SUBJECT: DUANE ARNOLD ENERGY CENTER - STAFF ASSESSMENT OF INFORMATION PROVIDED PURSUANT TO TITLE 10 OF THE *CODE OF FEDERAL REGULATIONS* PART 50, SECTION 50.54(f), SEISMIC HAZARD REEVALUATIONS FOR RECOMMENDATION 2.1 OF THE NEAR-TERM TASK FORCE REVIEW OF INSIGHTS FROM THE FUKUSHIMA DAI-ICHI ACCIDENT (TAC NO. MF3783)

Enclosure:
Staff Assessment of Seismic
Hazard Evaluation and Screening Report

STAFF ASSESSMENT BY THE OFFICE OF NUCLEAR REACTOR REGULATION

DUANE ARNOLD ENERGY CENTER

the DAEC Site

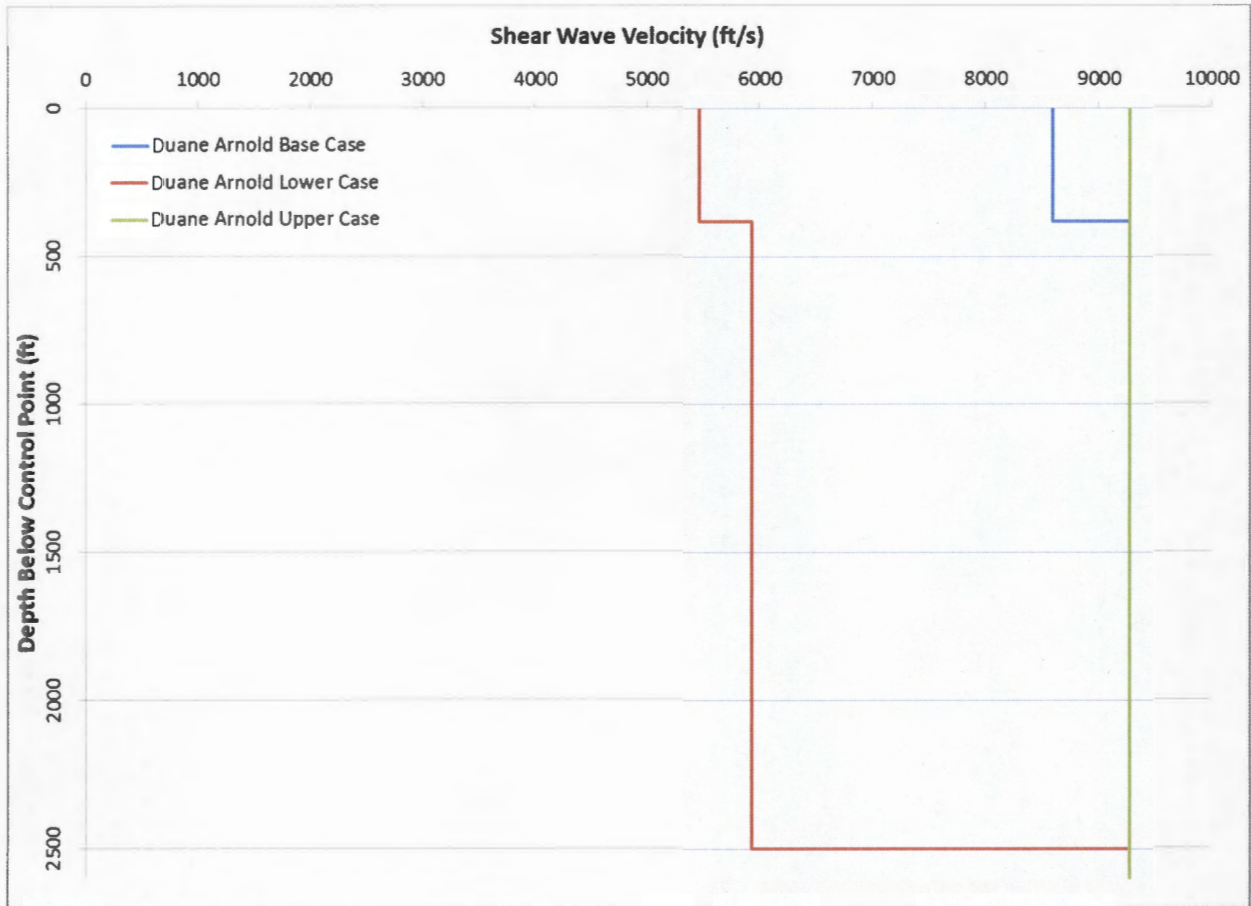
The licensee assumed the depth from the SSE to reference rock is either 380 ft. (116 m) at the top of the Ordovician, or 2,500 ft. (762 m). To capture the uncertainty in the shear wave velocity beneath the site, the licensee developed three base-case profiles using a scale factor of 1.57. The licensee used this scale factor and the estimated shear wave velocities to develop the base-case profiles for the DAEC site. For the best estimate base-case profile, the licensee assumed that reference rock conditions occur at a depth of 380 ft. (116 m) below the SSE, at the bottom of the upper limestone unit. For the lower range profile, the licensee assumed that reference rock conditions occur at a depth of 2,500 ft. (762 m), at the base of the sedimentary section. For the upper base-case, the licensee assumed that reference rock conditions occur at the depth of the SSE control point. Figure 3.3-1 of this assessment shows the licensee's three shear-wave velocity base case profiles.

To confirm the licensee's site response analysis, the NRC staff performed site response calculations for the DAEC site. Based on the limited subsurface data at the site and because the licensee followed the guidance in the SPID for sites with limited data, the NRC staff used the licensee's three base case shear wave velocity profiles for its confirmatory analysis. Figure 3.3- 1 of this assessment shows the licensee's and staff's three shear-wave velocity base case profiles.

Figure 3.3- 1 Plot Comparing the Staff's and the Licensee's Median Amplification Functions and Uncertainties for the DAEC site.

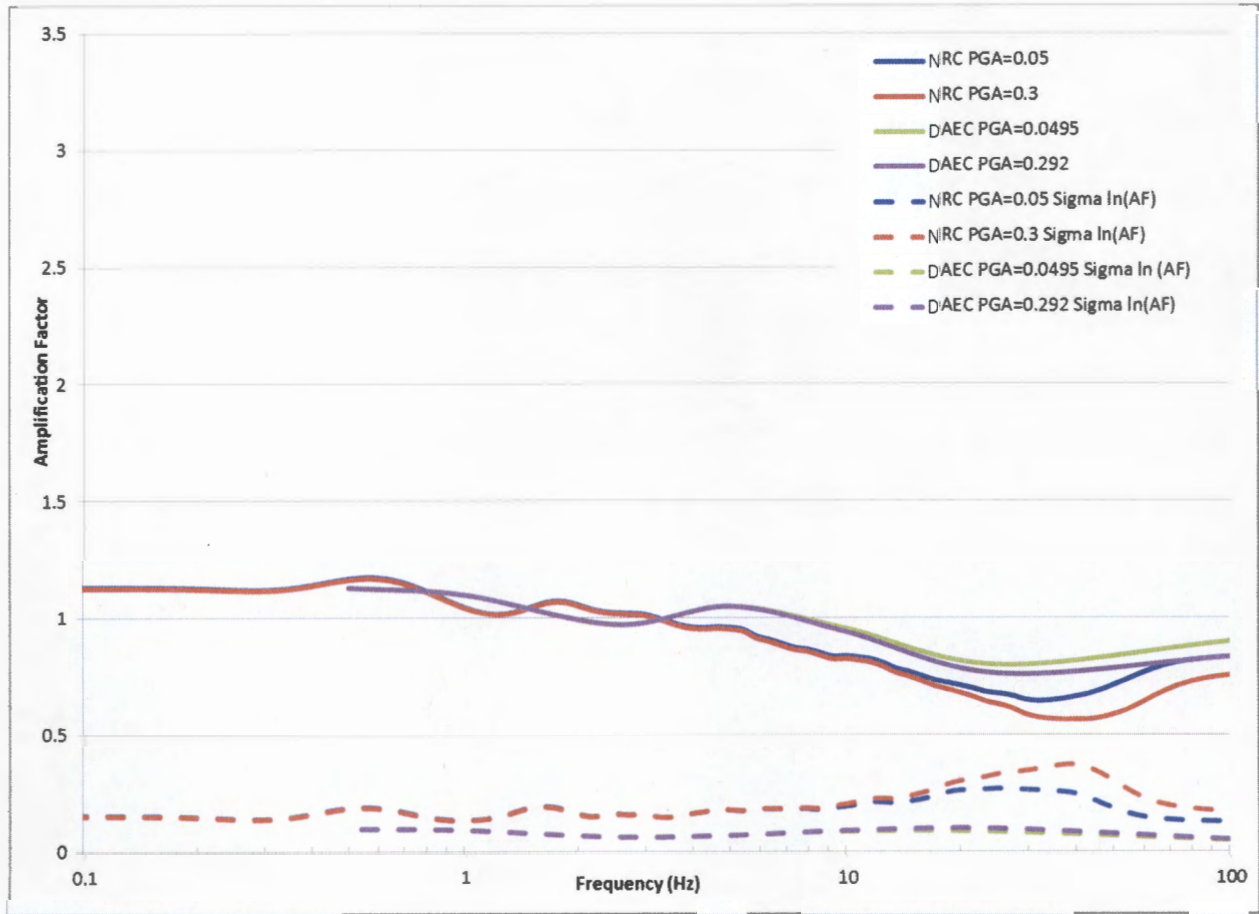
Figure 3.3-2 of this assessment shows a comparison of the NRC staff's and licensee's median site amplification factors and uncertainties (± 1 standard deviation) for two of the eleven input loading levels. As expected, due to similar site response analyses, the staff's median site amplification factors are very close to the licensee's. Based on the staff's confirmatory calculations of amplification factors, the NRC staff concludes that the licensee's evaluation for the DAEC site adequately captures the site amplification occurring as a result of bedrock ground motions travelling upward through the soil/rock column to the control point elevation.

Figure 3.3-2 Plot Comparing the Staff's and the Licensee's Mean Control Point Hazard Curves at a Variety of Frequencies for the DAEC site

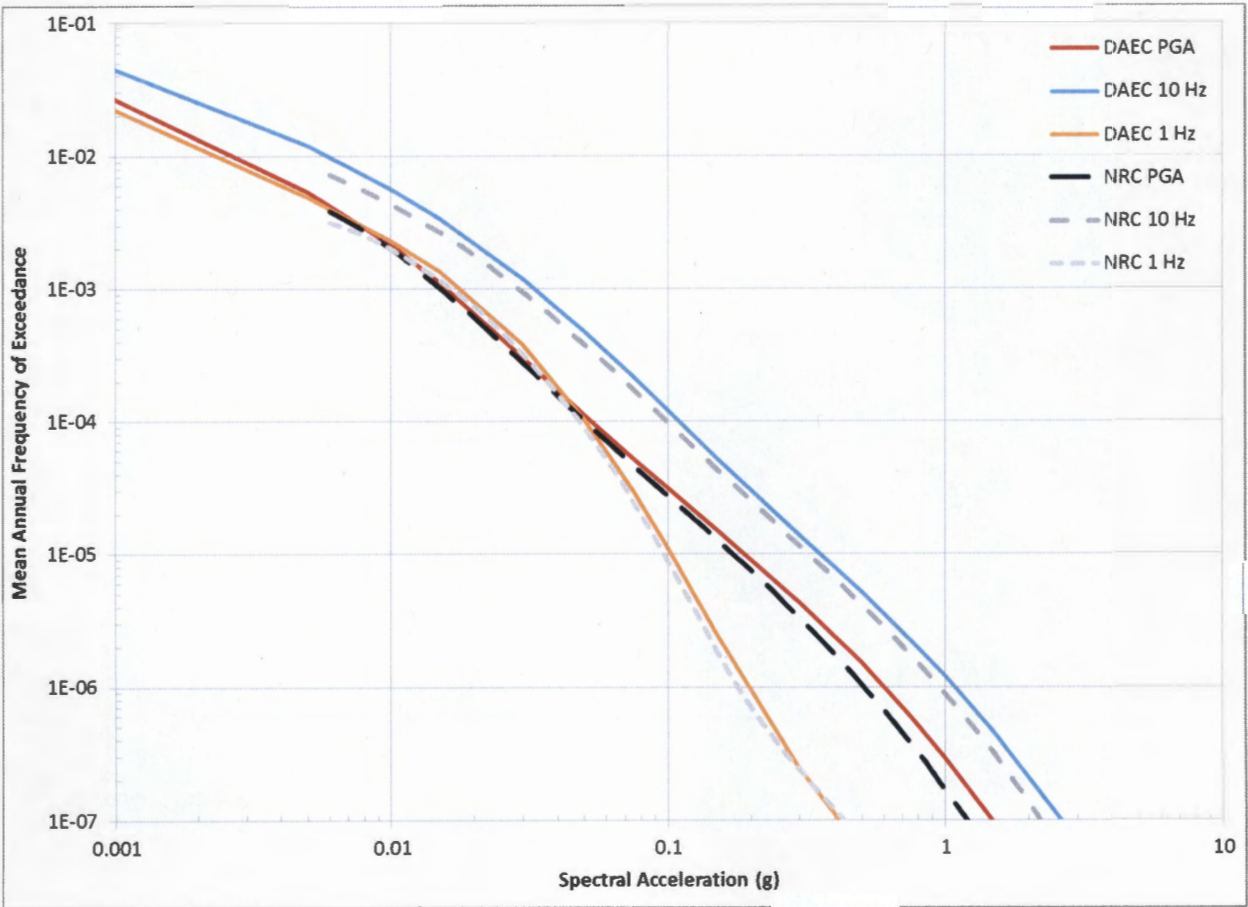
Figure 3.3-3 of this assessment shows that the licensee's and NRC staff's control point hazard curves are also very similar. Minor differences are due primarily to the licensee's use of higher low strain damping (three percent) than the damping value (one percent) used by the NRC staff for the rock. Appendix B of the SPID provides guidance for performing site response analyses, including capturing the uncertainty for sites with less subsurface data; however, the guidance is neither entirely prescriptive nor comprehensive. As such, various approaches in performing site response analyses, including the modeling of uncertainty, are acceptable for this application.

Figure 3.4-1 Comparison of the Staff's GMRS with Licensee's GMRS and the SSE for the DAEC site

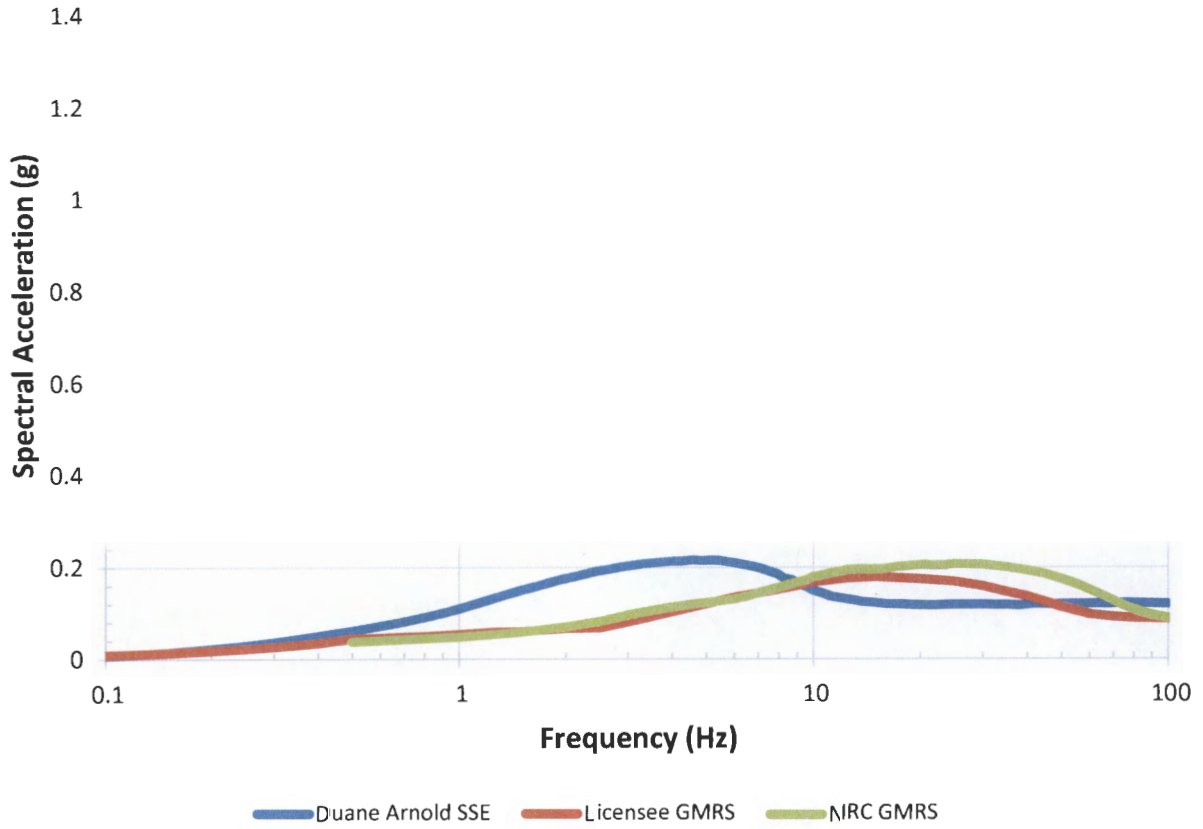
The NRC staff independently calculated the 10^{-4} and 10^{-5} UHRS using the results of its confirmatory PSHA and site response analysis, as described in Sections 3.2 and 3.3 of this staff assessment, respectively. Figure 3.4-1 of this assessment shows a comparison of the GMRS determined by the licensee to that determined by the NRC staff.

As shown in Figure 3.4-1, the licensee's GMRS shape is very similar to that calculated by the NRC staff. At higher frequencies, the staff's confirmatory GMRS is slightly higher than the licensee's. These differences in GMRS are the result of differences in the site response analyses performed by the licensee and NRC staff as discussed in Section 3.3 above.
